DSOS254A-03D

Modification Recommended Service Note

DSOS254A – DSO Infiniium S Series 2.5GHz 4 channel

The Problem – Under certain circumstances a PLL2 error may occur on the S-series products.

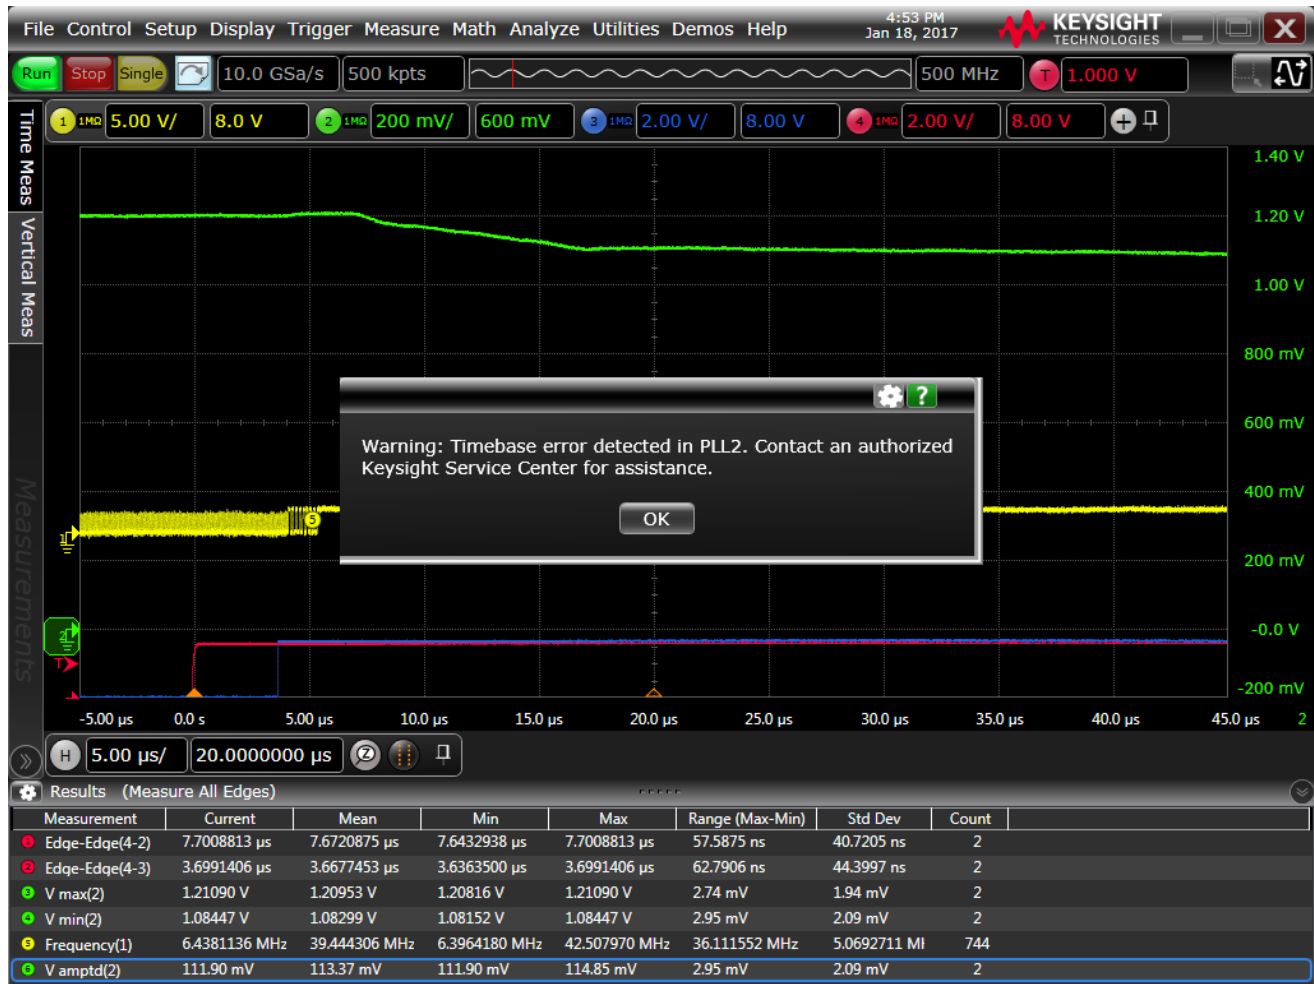
On older acquisition boards a PLL2 error message sometimes occurs. The error message appears on the screen as below:

There are new acquisition boards that fix this issue for the S-series scopes.

Please, use the 54911-69511 board until is gone.

If you have a 54911-69511, then skip steps 1 and 2 and proceed to step 3.

If there are no 54911-69511, then start with step 1 below.

1. If the customer needs to have software revision < 6.10.01001, then replace the acquisition board with the 54911-69532 board.
2. If the customer can have software revision >= 6.10.01001, then it can be replaced by any of these three boards: 54911-69521, 54911-69531, or 54911-69532.
3. Save the Serial Numbers of the replaced and the new Acquisition Boards in Siebel. Please, follow this procedure:
 - a. For each Service Order in Siebel, there is a tab labeled Activities:
